This document addresses known errata and documentation issues for the Triple Speed Ethernet MegaCore function version 7.1 SP1. Errata are functional defects or errors, which may cause the Triple Speed Ethernet MegaCore function to deviate from published specifications. Documentation issues include errors, unclear descriptions, or omissions from current published specifications or product documents. [Table 1](#) shows the issues that affect the Triple Speed Ethernet MegaCore function version 7.1 SP1.

Table 1. Triple Speed Ethernet MegaCore Function Version 7.1 SP1 Issues

Triple Speed Ethernet MegaCore Function v7.1 SP1 Issues

Figure 1. Triple Speed Ethernet MegaCore Function Wrapper

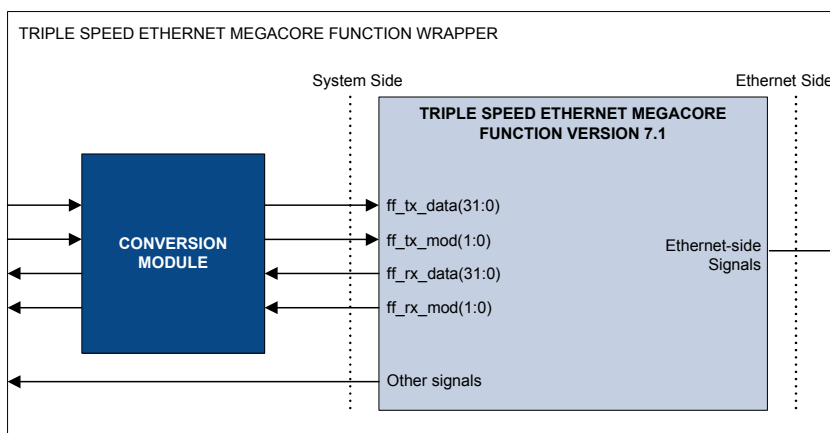
Missing section in the User Guide—Upgrading to Triple Speed Ethernet MegaCore Function Version 7.1 and Above

In compliance with the Avalon Streaming Interface Specifications, symbol ordering and data modulo signals in the Triple Speed Ethernet version 7.1 have been redefined. When upgrading to Triple Speed Ethernet 7.1 and above, Altera recommends existing customers who are using the following cores to add a conversion module as described in the section “Required Conversion”:

To upgrade the Triple Speed Ethernet MegaCore function in your design to version 7.1 and above while maintaining compatibility with existing custom logic, add a conversion module as illustrated in [Figure 1](#).
